# SCHWEIZER SERVICE BULLETIN

B-290  
26 Sep 2008

**SUBJECT:** LANDING GEAR SKID TUBE AFT SLEEVE INSPECTION

Figure B-290-1. Aft Sleeve

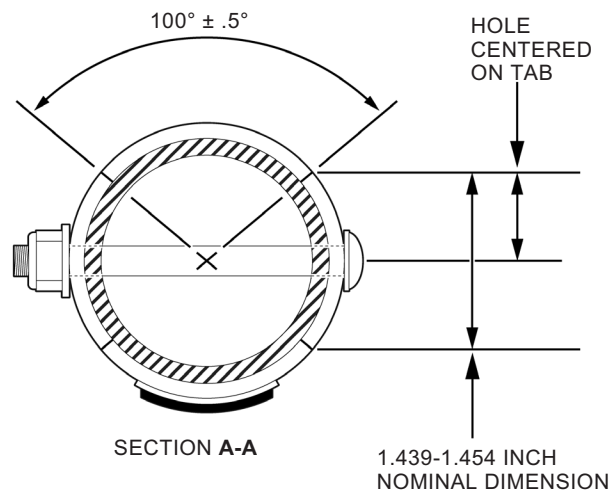
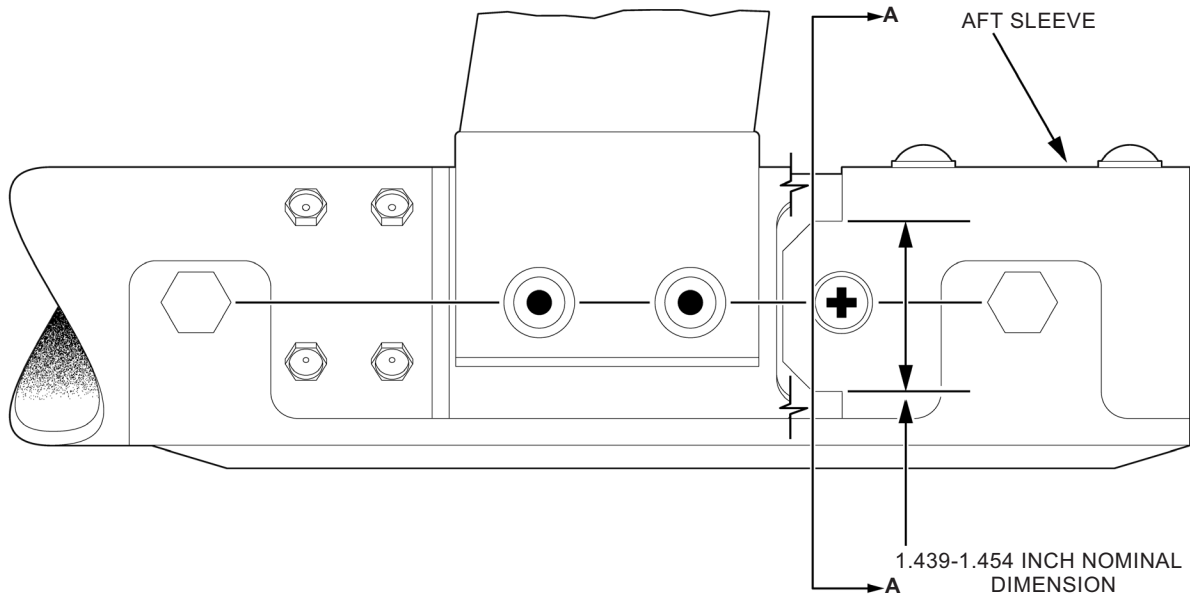
- It has come to our attention that the tabs of some aft sleeves have been machined incorrectly and this causes a restriction in the rotational travel of the associated component. A dimensional check of the aft sleeve will expose any restriction in the rotational travel.

- a. Install ground handling wheels and raise aft skid sleeve extension from ground.
- b. Using a caliper, measure both tabs of aft sleeves as shown in Figure B-290-1. Dimension of aft sleeve tabs should be between 1.439 to 1.454 inches.
- c. If either tab dimension is over 1.454 inches, replace aft sleeve with serviceable sleeve in accordance with Basic HMI Section 12 within next 100 hours of flight time or 3 months whichever comes first.
- d. Measure all spare aft sleeves in stock purchased between December 2007 and July 2008 for tab dimension of 1.439 to 1.454 inches. Remove from stock all sleeves that do not pass inspection.
- e. Record compliance with this Service Bulletin in the aircraft records.
